Access Compliance Report

Public Rights-of-Way

(Pedestrian Signals)

Intersection ID: N/A	Main Street:	Cross Street: N/A	Location: N/A
ADA ID: 7CA7F3EB1FD6	Signal Type: One Push Button-Non APS	Overall Compliance: No	Severity Score: BTN 1: N/A BTN 2: N/A No BTN: N/A
Codes/Mitigation Info/Possible Solution		Field Measurements/Component Compliance

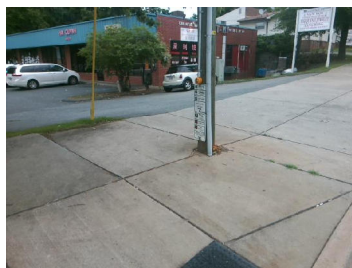
Surveyor Notes: TEXT HT 1/2

PROW/ADA: R410.6, TMUTCD 4e.08, R404.2

Possible Solutions: Replace Signal Push Button With APS Button on New Post. Remove & Replace Sign.
